Office Action Summary	Application No. 10/597,205	Applicant(s) HELDBERG ET AL.	
	Examiner JONATHAN BRADFORD	Art Unit 3744

DETAILED ACTION

2. **Claims 11, 15-16, and 19 are rejected** under 35 U.S.C. 103(a) as being unpatentable over Saur (US 4,674,679) in view of Henschel (DE 4231649).

Saur

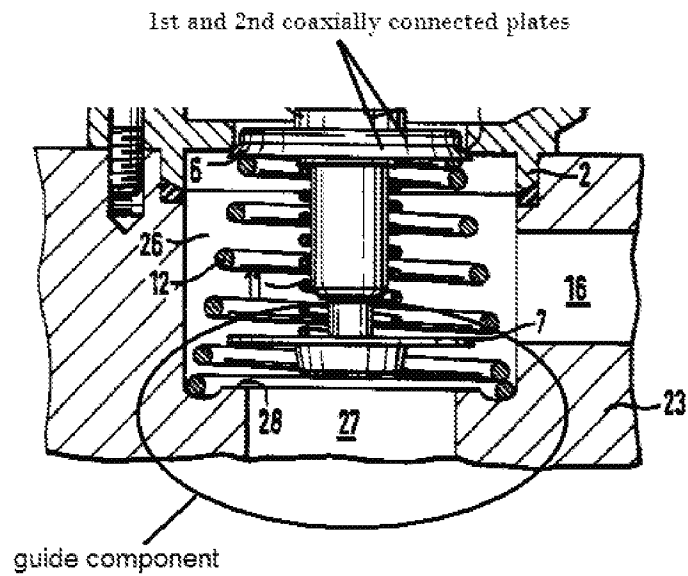
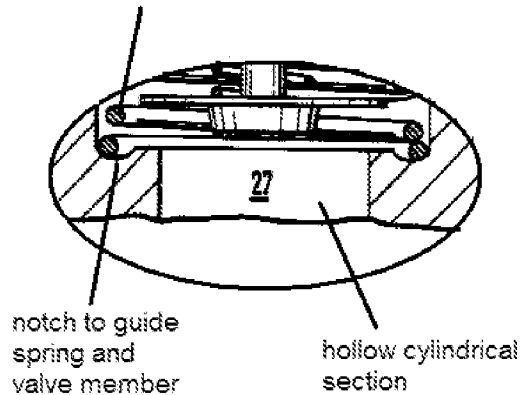
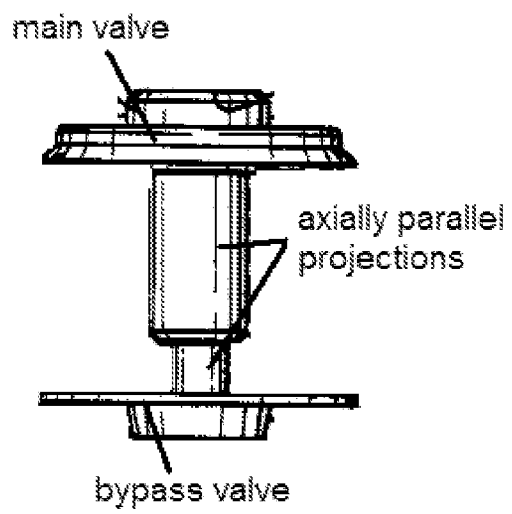
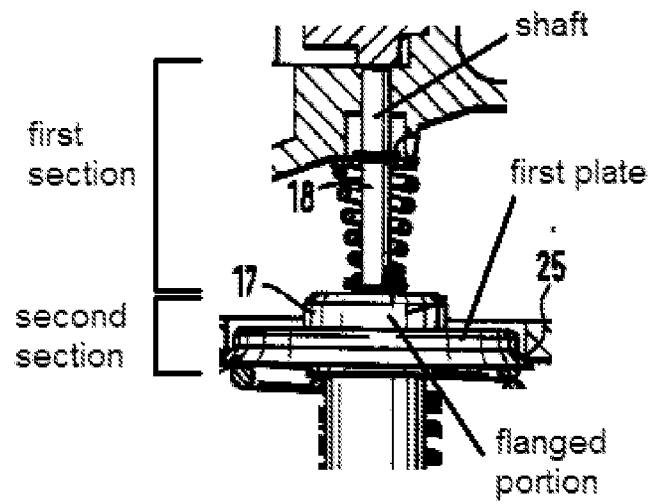
As to claim 11, Saur teaches a thermostat valve arrangement for a cooling circuit of an internal combustion engine (col. 1, lines 6-8), the arrangement comprising: a housing having a sealing valve seat 25 and formed from an upper valve housing 1 and a lower housing 23; a guide component that is a section supported by the housing and consisting of a notch holding a spring 12 to guide the opening and closing of the valve as well having a hollow cylindrical section 27 (see annotated figures); a main valve member 6 moveably engaged with the valve seat 25; a bypass valve member 7 spaced from the main valve member 6 in an axial direction and movably engaged with the hollow cylindrical section 27 of the guide component; an expansion element comprising wax within the body 17 (col. 3, lines 19-20) and a piston element 18 having a first section and a second section, the first section cooperable with an abutment fixed to the housing (col. 4, lines 1-5) and the second section cooperable with the main valve member 6 and the bypass valve member 7 (col. 4, lines 6-13) in an axial direction of the main valve member such that the valves are opened and closed to produce the cooling

circuit of the engine; and a valve spring 12 that is between the main valve member 6 and the guide component and surrounds the expansion element and the entire hollow cylindrical section of the guide component (see annotated figures), wherein when the main valve member 6 is closed, the main valve member is biased by the valve spring 12 to be directly engaged with the main valve seat 25 and the bypass member 7 is disengaged from the hollow cylindrical section of the guide component (as shown in Fig. 1), and when the main valve member 6 is open, the main valve member 6 is pressed by an expansion of the expansion element and disengaged from the main valve seat 25 and the bypass valve member 7 is pressed by the expansion element into the hollow cylindrical section of the guide component (col. 4, lines 1-13).

As to claim 15, Saur, as modified, teaches a main valve member 6 which is connected to the bypass valve member 7 by parallel projections which extend axially (see annotated figures).

As to claim 12, Saur, as modified, teaches a main valve member 6 formed from a first plate and a second plate coaxially connected to the first plate (see annotated figures). Saur, as modified, does not explicitly teach a sealing ring sandwiched between the plates that is directly engageable with the main conical sealing valve seat. However, Griffin teaches using a sealing ring 60 sandwiched between two coaxially connected plates 40 and 46 to seal against conical valve seat. It would have been obvious to a person having ordinary skill in the art, at the time of the invention, to further modify the valve member 6 of Saur to include a sealing ring sandwiched between the coaxially connected plates as taught by Griffin, because it would prevent the valve from being

As to claim 14, Saur, as modified, teaches an expansion element with a shaft 18 at the first section which faces the main valve seat, while a flanged second section is received in a complementary recess of the first plate (see annotated figures.)

spring surrounding notch and cylindrical
section which make up guide component

The applicant argues that the applied art fails to disclose or suggest the amended feature of a valve spring that surrounds the entire hollow cylindrical section of the guide component. The examiner respectfully disagrees. Fig. 1 of Saur shows a valve spring 12 which surrounds the entire circumference of the hollow cylindrical section 27. Therefore the spring is considered to meet the limitation as it surrounds the circumference of the cylindrical section in its entirety.

Henschel

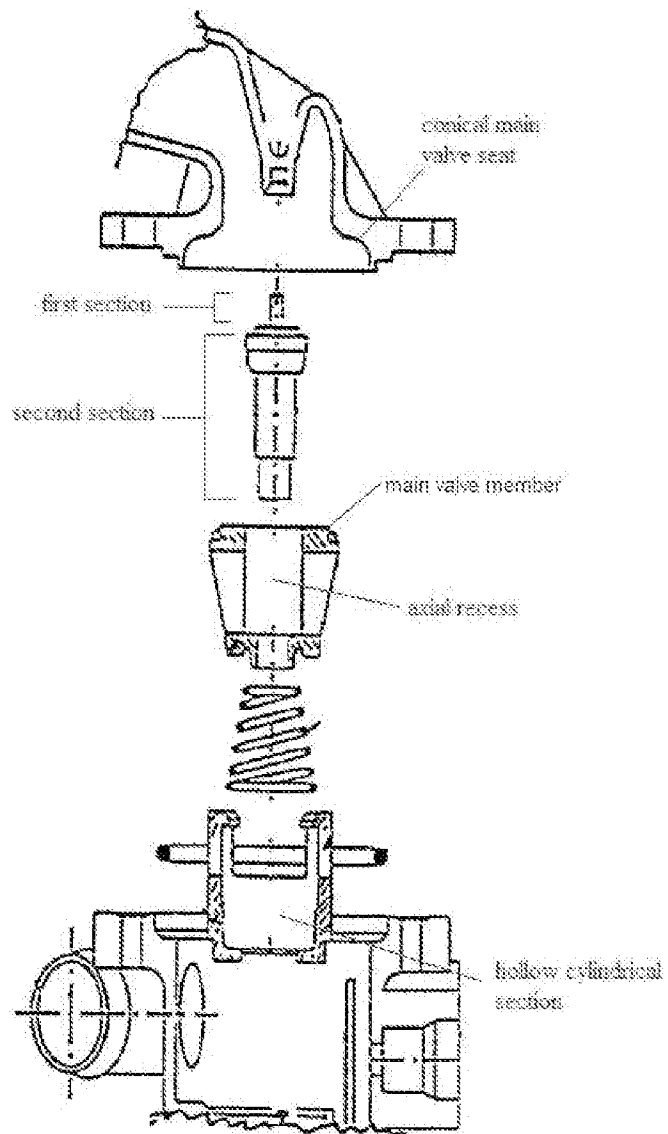
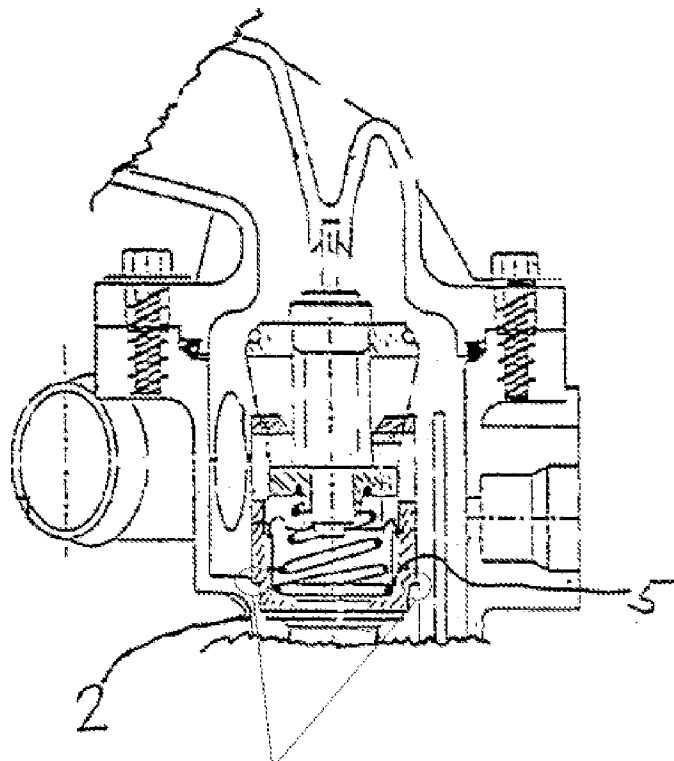
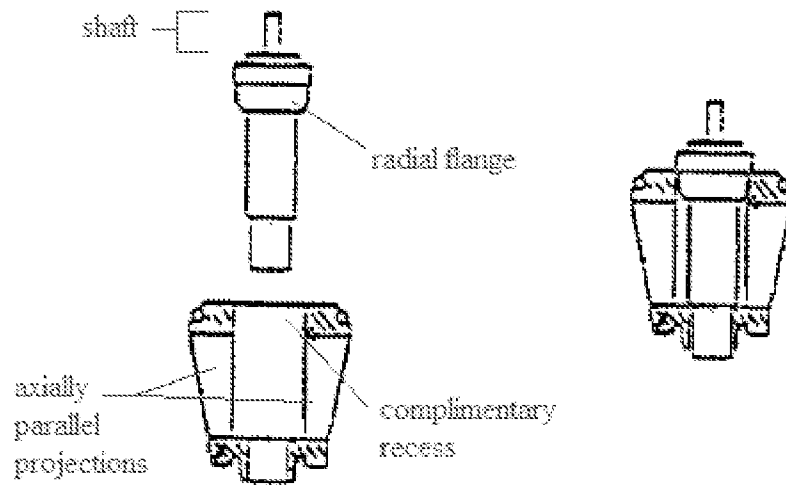
As to claim 22, Henschel discloses a three way thermostat valve arrangement for the cooling circuit of an engine having: a housing formed by the upper portion 1 and the lower portion 2 and having a conical sealing seat; a guide component 5 axially supported in the housing and having a hollow cylindrical section; a main valve member engageable with the sealing seat; a bypass valve member 22 which is spaced from the main valve member in an axial direction and is movably engaged with the hollow cylindrical section of the guide component; an expansion element 3 with a first section 18 and a second section, where the first section 18 cooperates with an abutment 19 fixed to the housing and the second section cooperates with the main valve member and the bypass valve member so that both the main valve and the bypass valve 22 can either be selectively closed or opened in order to direct coolant to either a radiator or a bypass (Fig. 3); and a valve spring 6 between the main valve and the guide component 5 (for elements not specifically noted in the rejection, please refer to the annotated figure); wherein when the main valve is closed, the main valve member is biased by the valve spring 6 to be engaged with the main valve seat while the bypass member is disengaged from the hollow cylindrical section, and when the main valve is open, the main valve member is pressed by the expansion element and disengaged from the main seat while the bypass is pressed into the hollow cylindrical section (Figs. 2 and 3).

As to claim 25, Henschel, as modified, teaches an expansion element comprising a shaft at the first section facing the main valve seat and a radial flange at the second section received in a complementary recess of the valve member which faces the flange (see annotated figure).

As to claim 26, Henschel, as modified, teaches connecting the main valve member with the bypass valve member with axially parallel projections (shown in annotated figures).

As to claim 27, Henschel, as modified, includes a valve member equivalent to first and second plates as stated in the rejection of claims 23-24 above. Further, the lower portion of the main valve member (analogous to a "second plate") is connected with the bypass valve member via the projections and the elements form an integral component (see annotated figures).

As to claim 30, Henschel teaches a guide component 5 that has an annular rib which fits securely into an annular groove of the lower portion 2 that supports the guide component (see annotated figures).

Annular rib of guide component 5 fits securely into an annular groove of the lower portion 2 which supports the guide component.
